Bid #2118

Covered Walkway for Anderson County Schools' Preschool and HeadStart Building

Questions & Answers

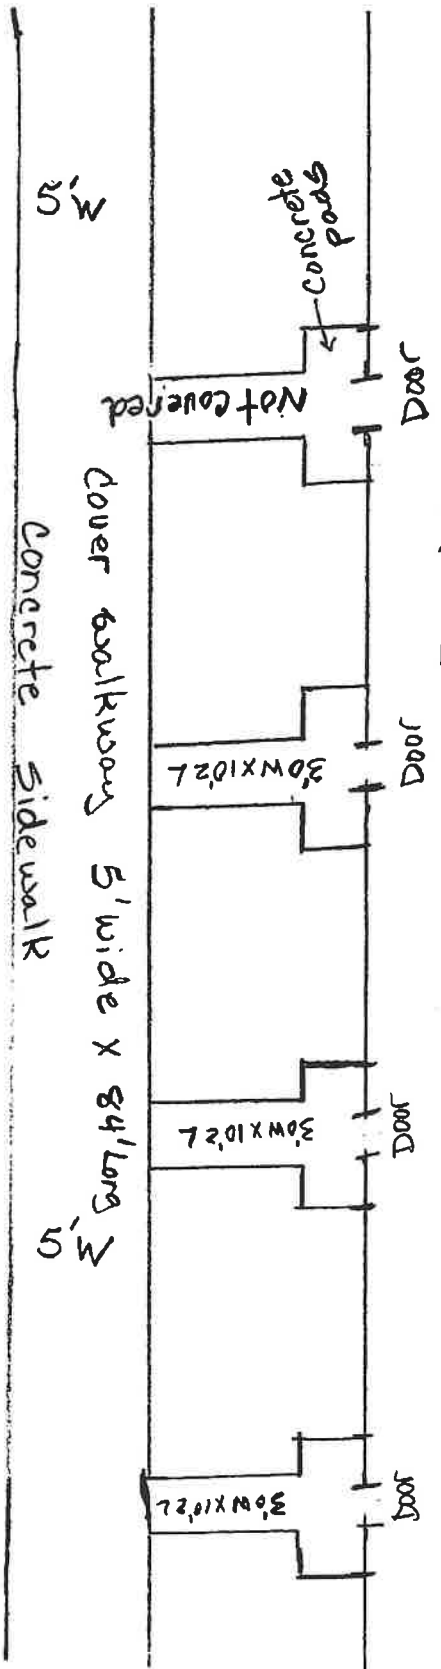
1. Can you provide a site plan that shows the layout of the canopies?

2. Is it acceptable to the owner if the canopies are fastened directly to the sidewalk or are foundations required?

Answer: It is attached.

Answer: The canopy is to be placed in the concrete with no footers.
